Office Action Summary

10/585,091

GING ET AL.

FIG. 44

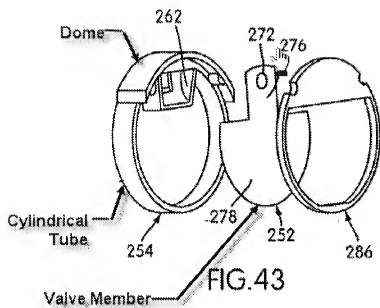
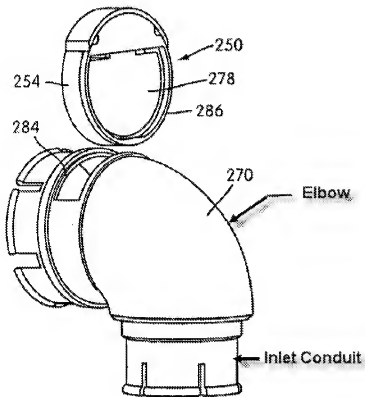
16. **As to claim 58**, Dantanarayana teaches an apparatus that comprises a frame **32** (see **fig. 4; paragraph [0071]**); an elbow (see **fig. 44**) provided to the frame and including an inlet

conduit (see fig. 44 below) and a valve member 278 (see fig. 43 below) provided between the frame and the elbow, the valve member being configured to allow breathing of ambient air and to prevent back flow of gas towards the inlet conduit of the elbow in an unpressurized state (see fig. 42; the figure shows arrows in both direction in the exhaust port indicating that that it allows breathing of ambient air and the fact that the valve 278 is closed prevents back flow of gas towards in the inlet conduit).

17. As to claim 59, Dantanarayana teaches an apparatus wherein the elbow includes an internal cylindrical tube 254 (see fig. 43 below) in communication with atmosphere and a dome (see fig. 43 below) that supports the tube, and wherein any back flow is guided through the tube and not the inlet conduit in the unpressurized state.
